STATE OF WASHINGTON  
DEPARTMENT OF ECOLOGY

**Re: Further Action at the following Site:**

- **Site Name:** Tacoma Public Utilities (TPU) Transformer at POT Pier 7
- **Site Address:** 2201 Sitcum Way, Tacoma, Pierce County, WA
- **Facility/Site No.:** 15369
- **VCP Project No.:** SW1561

This opinion letter provides comments on Robinson Noble's *Draft work plan for additional soil and groundwater investigation near Port of Tacoma Pier 7, Tacoma, Washington*, dated, October 14, 2016. The work plan proposes additional investigation related to a release of 143 gallons of mineral oil from an electrical transformer.

<b>ROBINSON NOBLE</b>	Note: Basemap taken from USGS Tacoma North Quadrangle	PM: MTW May 2015 1922-318A	Pierce County T 21 N/R 03 E - 34 Scale 1" = 500'	Figure 1 <b>Vicinity Map</b> Tacoma Public Utilities: Pier 7 Transformer Cleanup
--	---	----------------------------------	--	--

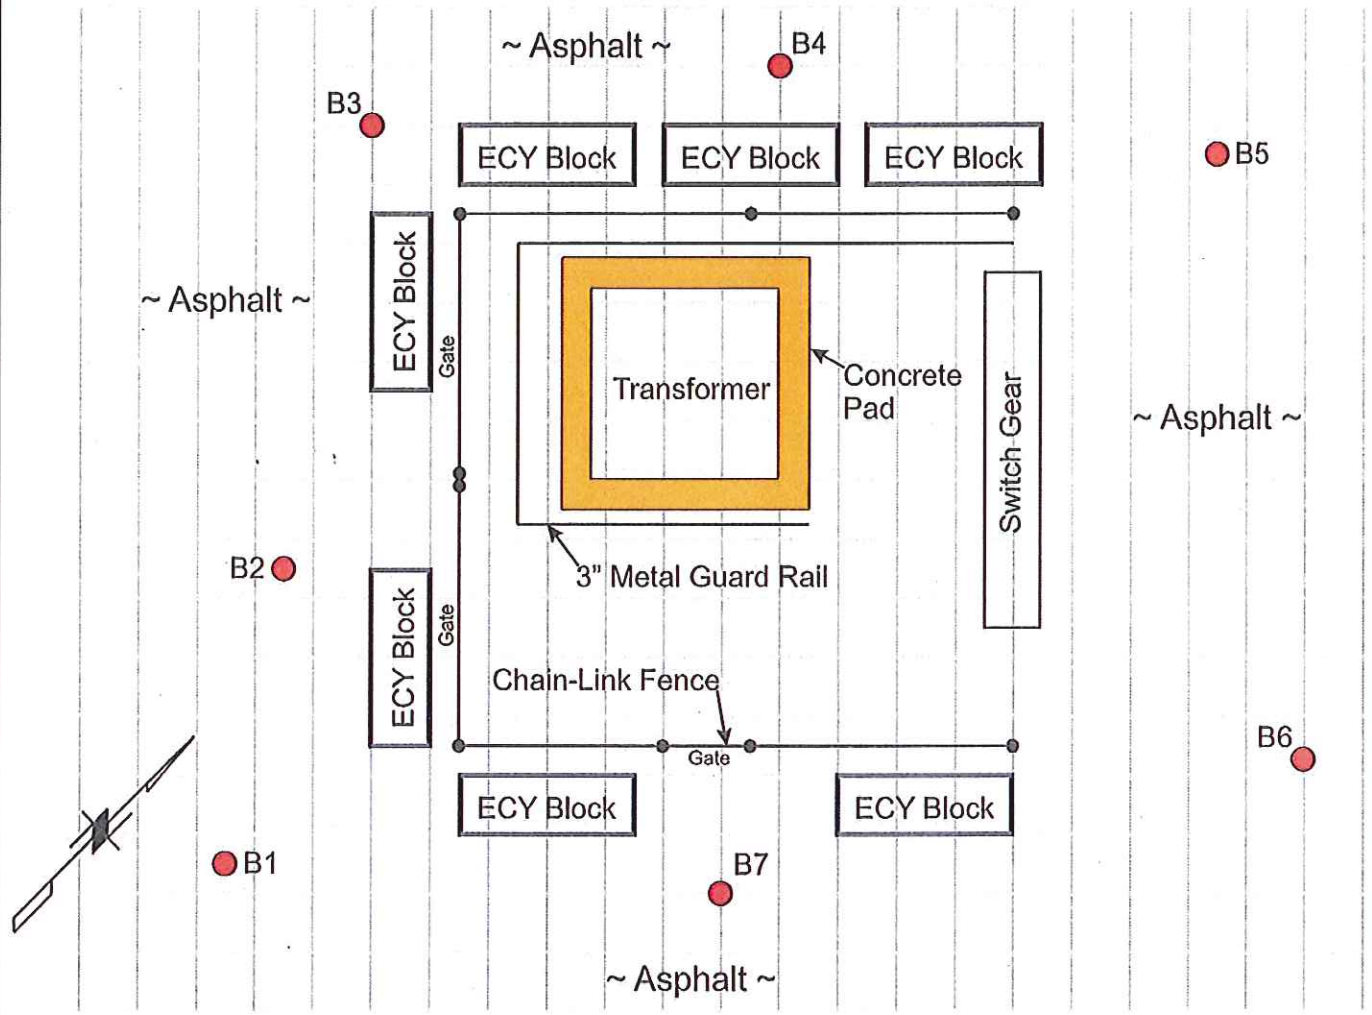
The pad-mounted transformer described in the work plan is a 750 KVA, industrial-type unit owned and operated by TPU, and is located on Port of Tacoma property (Figure 1). The surrounding area is paved with concrete and asphalt and is used for staging shipping containers. TPU reported that the transformer failed, releasing a total of 143 gallons of mineral oil (dielectric fluid). Based on TPU records, the mineral oil was believed to not contain polychlorinated biphenyls (PCBs). Immediately under the concrete pad, the concentration of TPH as mineral oil in soil was 136,000 milligrams per kilogram (mg/kg). The release was reported to Ecology via email on April 22, 2015 and entered into Ecology's Environmental Report Tracking System (ERTS). Per that email, the release was discovered on January 22, 2015.

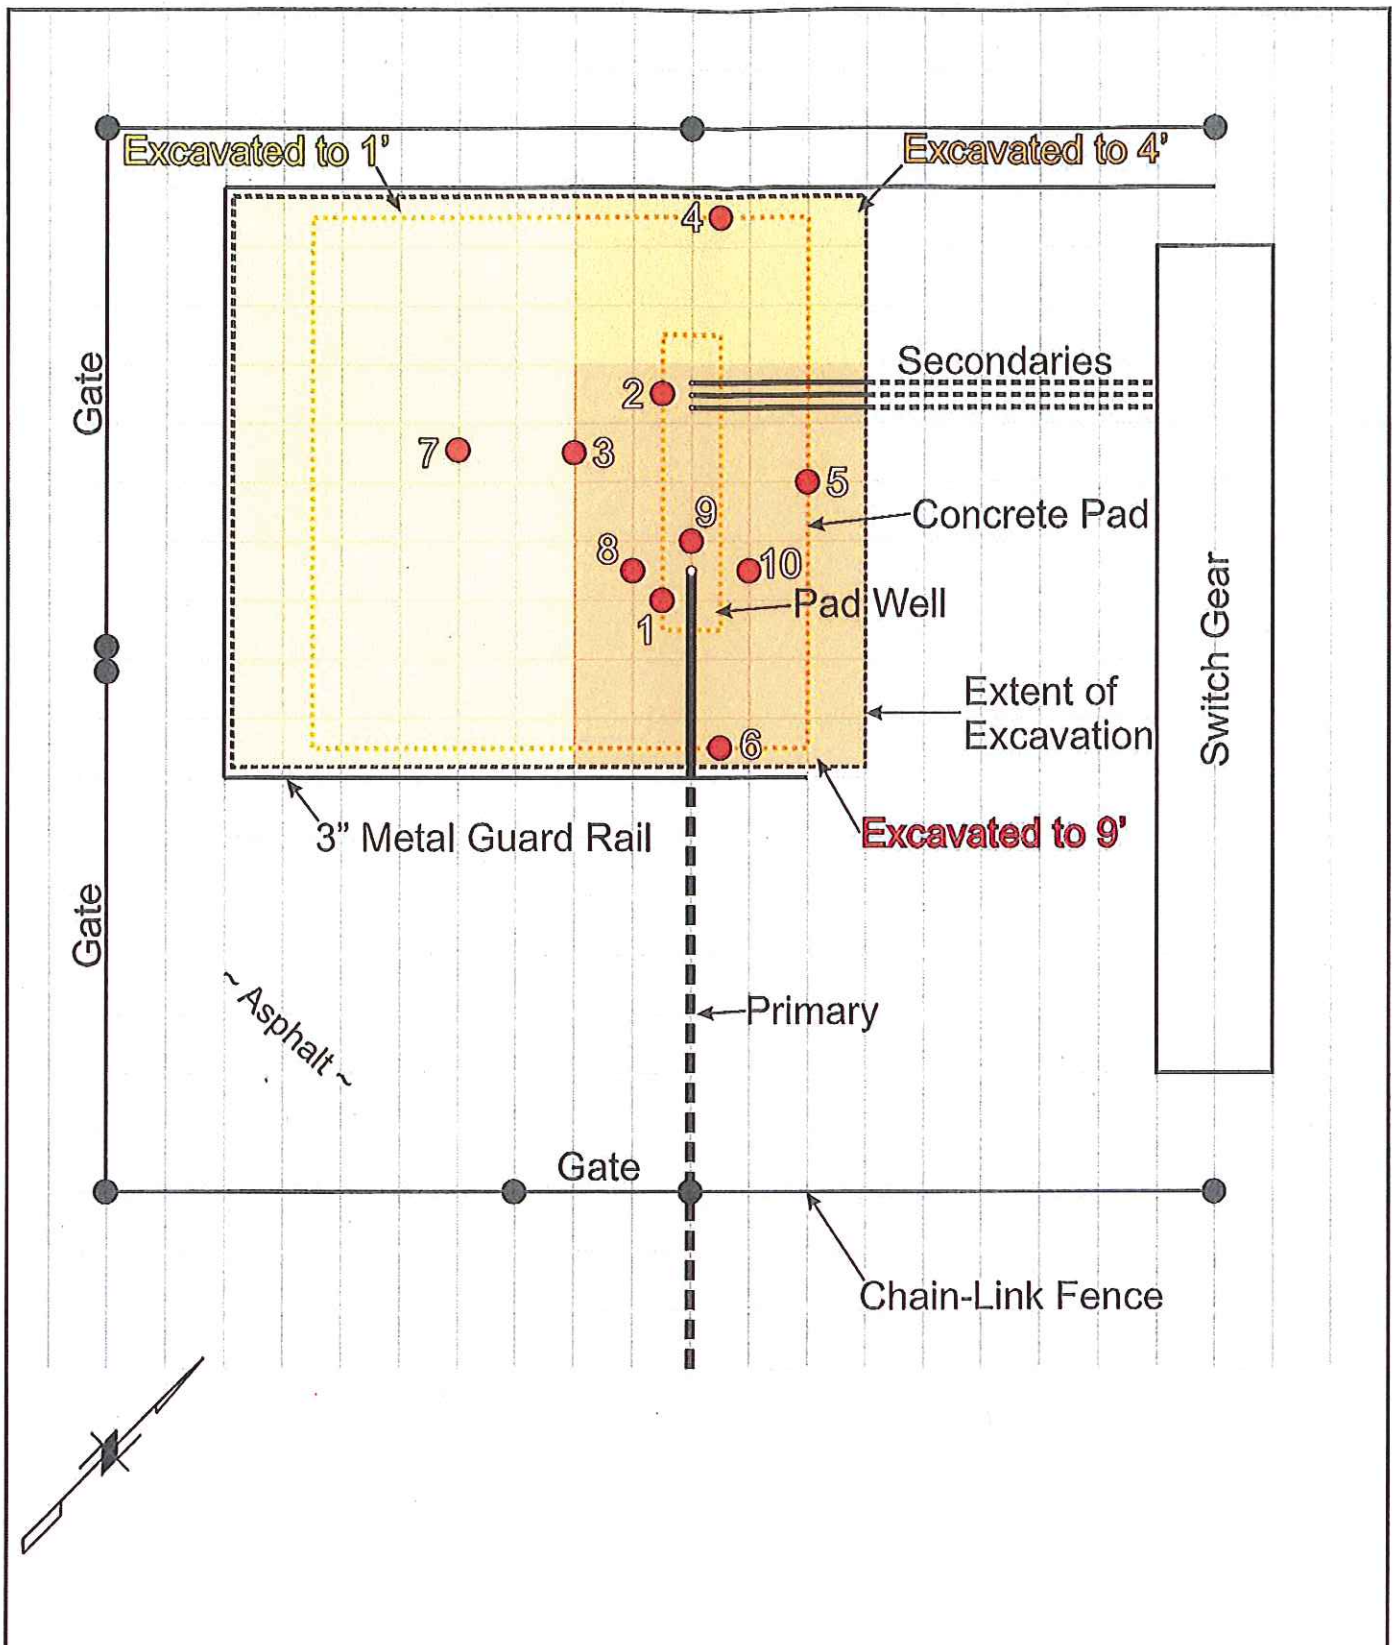
On May 4, 2015, Robinson Noble conducted a preliminary assessment of subsurface conditions in the area immediately around the transformer. Robinson Noble advanced seven direct push borings (B1 through B7) and collected soil samples (Figure 2). Grab groundwater was sampled from borings B1, B3, B5, and B6. No concentrations of mineral oil were detected in soil or groundwater sampled.
